ADDENDUM 1

PROJECT NAME: APACHE CREEK LINEAR PARK LIGHTING UPGRADES

DATE: September 11, 2020

PROJECT NO: 29652000

SHEET:
ESD1.1

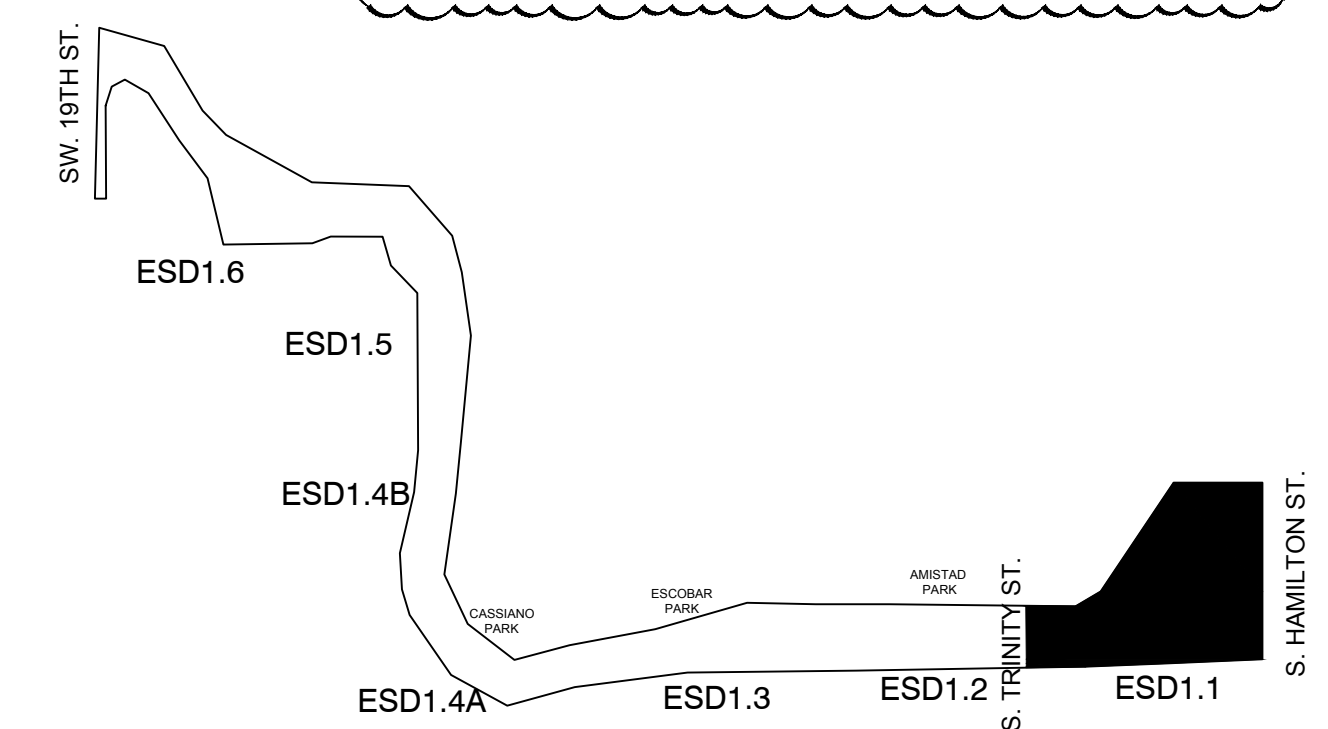
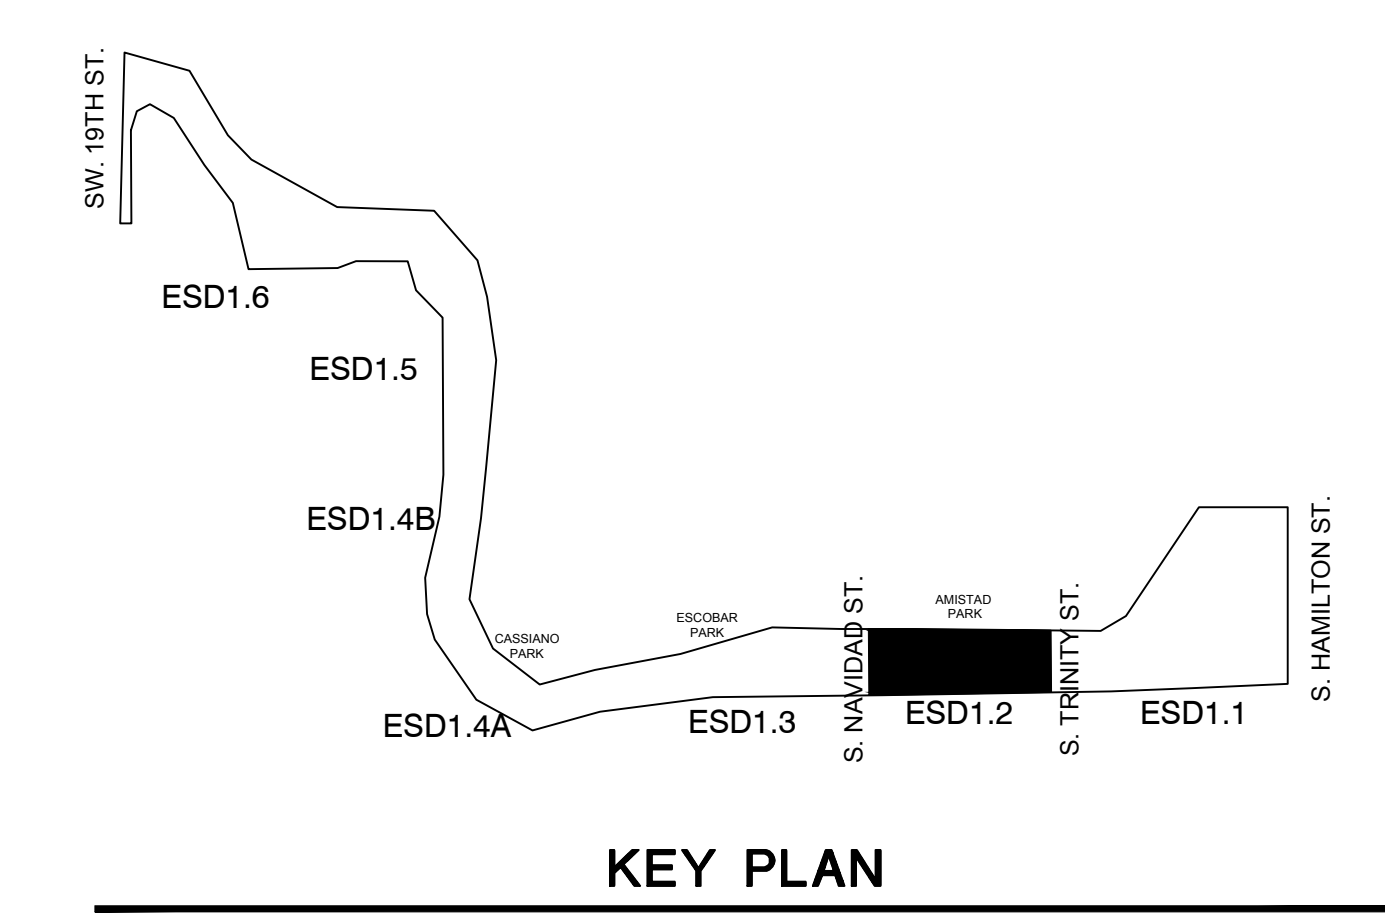
- i. RE: Plan Sheet ESD1.1:
 - a. Item 1: Revised key note 1.
 - b. Item 2: Added key note 3.
 - c. Item 2: Revised general note 7.

- Answer: By COSA
6. Sheet ESD1.1 - Demolition note #7 - salvaged items should be returned to the owner - Are there any demolished items the owner would like? If so what is the designated storage facility where they are to be delivered?

- Answer: Key note #7 has been revised on sheet ESD1.1. See addendum 01
7. Throughout the project various areas of the trail will be affected by equipment tire tracks, etc. Plans call for restoration of lay-down areas to be used for the project but there is no mention of access damage restoration. To what extent will this restoration be necessary?

1. EXISTING LIGHT POLE AND ASSOCIATED ELECTRICAL COMPONENTS TO BE REMOVED. REMOVE ASSOCIATED POLE BASE DOWN TO 2'-0" BELOW GRADE, ABANDONED REMAINDER IN PLACE.
2. ALL UNDERGROUND CONDUIT SERVING LIGHT POLES TO BE ABANDONED 24" UNDERGROUND.
3. EXISTING CONDUIT AND ASSOCIATED FEEDER ROUTED ACROSS BRIDGE TO BE REMOVE.

SHEET:
ESD1.2

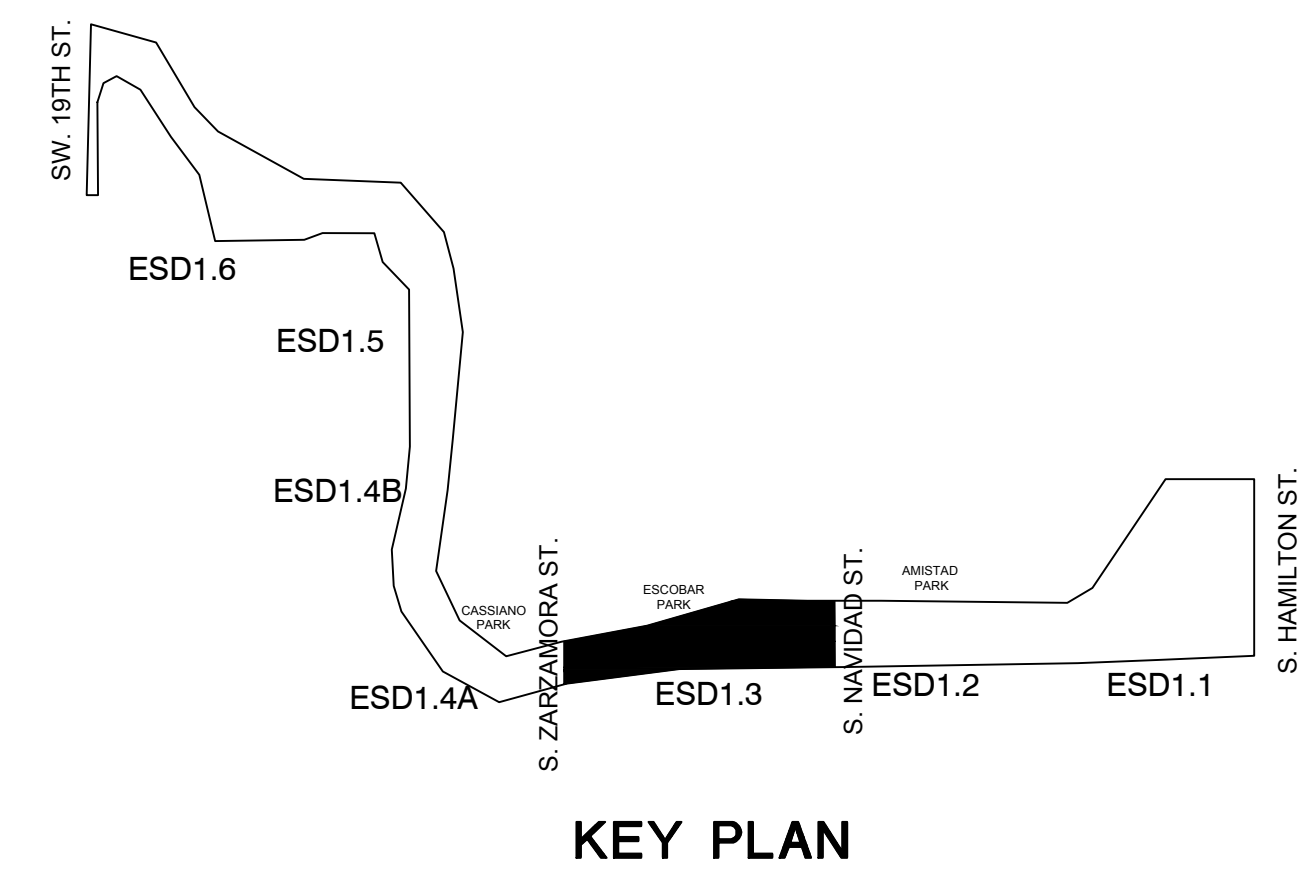
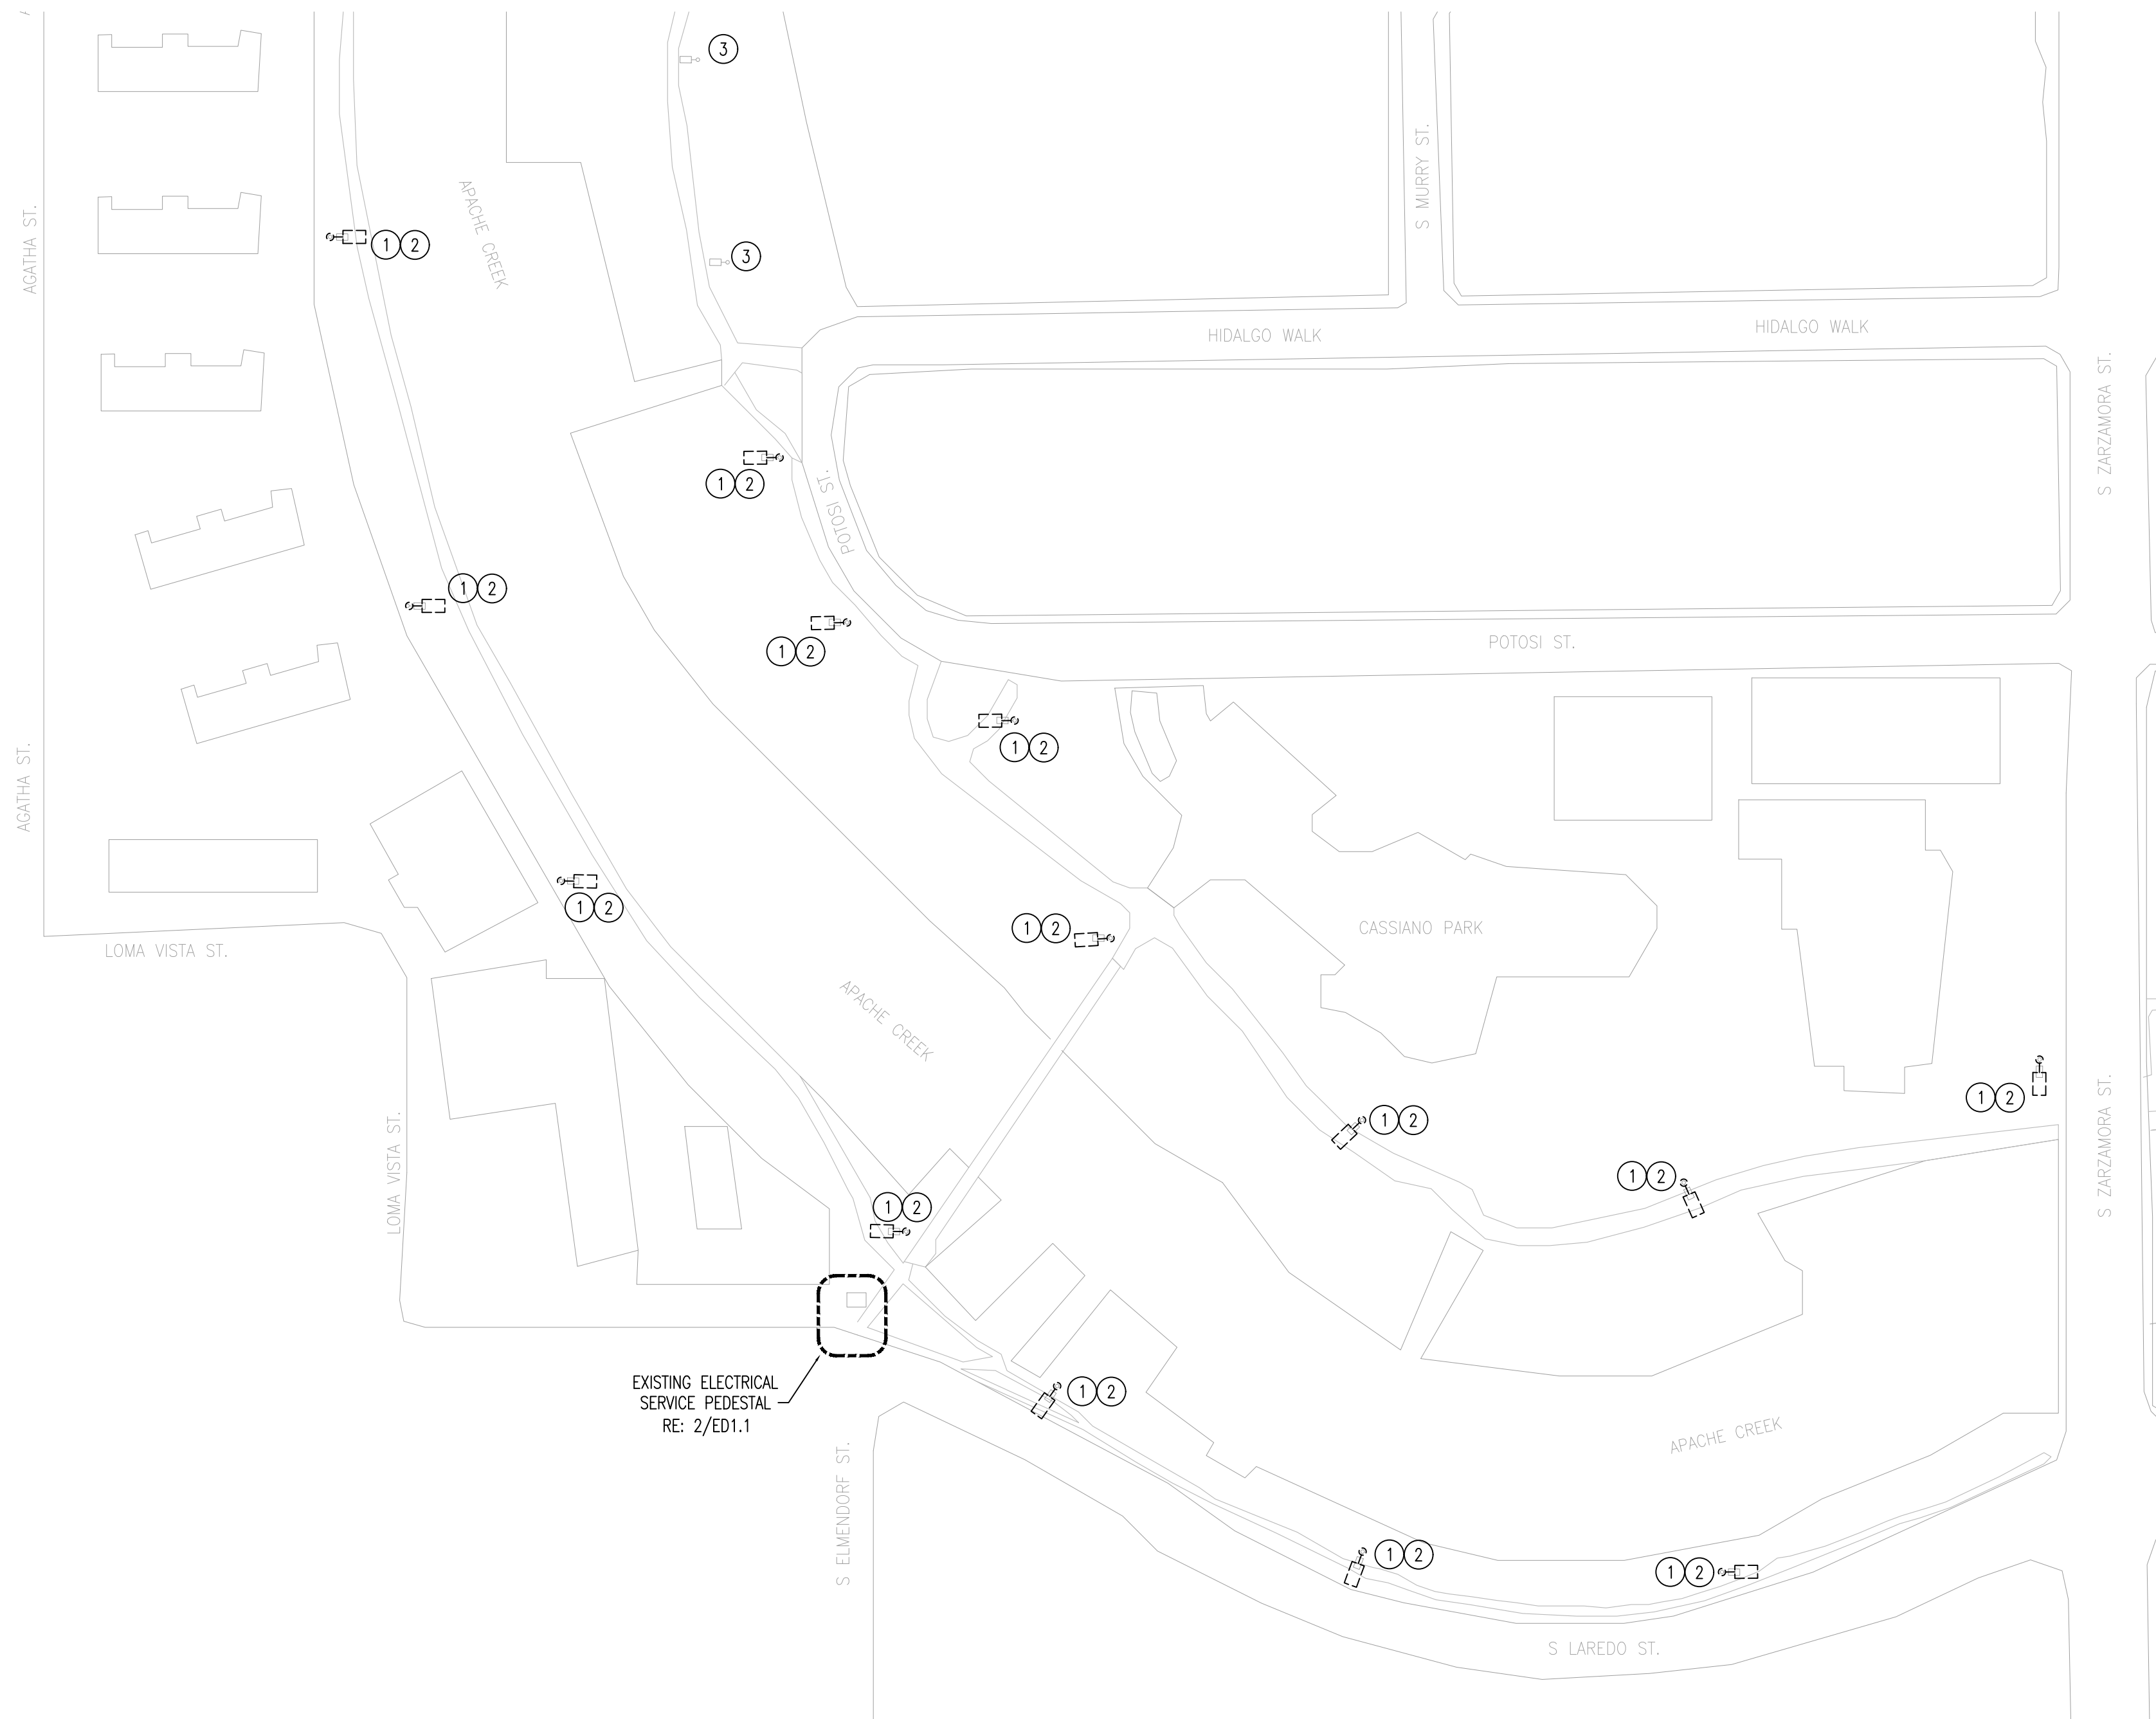
- ii. RE: Plan Sheet ESD1.2:
 - a. Item 1: Revised key note 1.
 - b. Item 2: Added key note 3.
- iii. RE: Plan Sheet ESD1.3:
 - a. Item 1: Revised key note 1.

- KEYED NOTES:** (APPLIES TO THIS SHEET)
1. EXISTING LIGHT POLE AND ASSOCIATED ELECTRICAL COMPONENTS TO BE REMOVED. REMOVE ASSOCIATED POLE BASE DOWN TO 2'-0" BELOW GRADE, ABANDONED REMAINDER IN PLACE.
 2. ALL UNDERGROUND CONDUIT SERVING LIGHT POLES TO BE ABANDONED 24" UNDERGROUND.
 3. EXISTING CONDUIT AND ASSOCIATED FEEDER ROUTED ACROSS BRIDGE TO BE REMOVE.
